| DART AEROSPACE LTD | Work Order: | 24096 |
| Description: Support Assembly | Part Number: | D3278-041 |
| Dwg: D3278 Rev. 1 3/27/05.06-07 | Qty: | 100 98 |

05.04.04 *[Signature]*D3278-1 SUPPORT (SHOWN)D3278-2 SUPPORT (OPPOSITE)

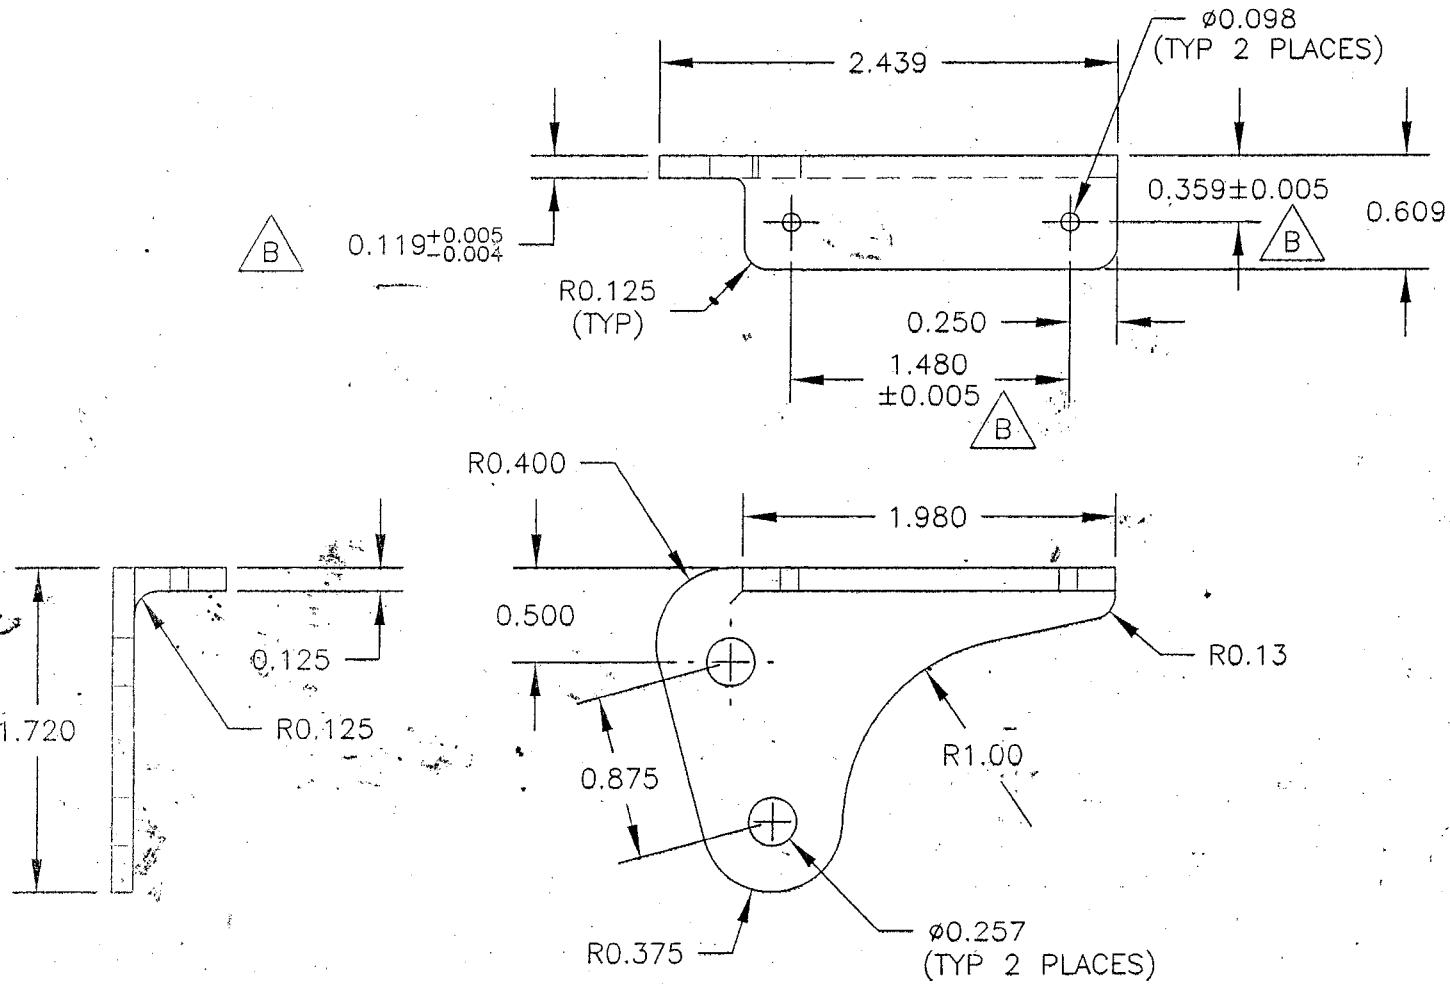
| | | WORK ORDER NON-CONFORMANCE (NCR) | | | | | | |
|----------|------|---|-----------------------------|--|----------------------|---------------------------|--|--------------------------|
| 05/10/12 | 4 | - 10 parts are under tolerance - 119 ^{+ .005} - .004 3278-1 - ranging between .108 and .113 - are parts acceptable? | CP | PARTS ARE OK. WHEN ASSEMBLING, ENSURE PROPER BOLTS DO NOT Bottom OUT. | J.L 05.10.12 | <i>AB</i> 05-10-17 | <i>Q</i> 05.10.17 per QSI 042 | <i>AB</i> 05-10-17 |

> David,
>
> They made (10) D3278-1 brackets (that's the bracket for the fwd 350 step
> clamp) with a reduced wall thickness. The end of the piece was lifting on
> the machine, so the wall tapers from nominal down to 0.108" (minimum) at
the
> lower hole. The nominal is 0.119 +0.005 -0.004.
>
> They've fixed the problem so this didn't happen on the rest of the batch.
>
> Is this acceptable.
>
> -Chris
>
>
>

Structurally, I don't see a problem with the thin parts. I would double check that the assembly works OK with the plastic spacers and the clamps before signing these parts off.
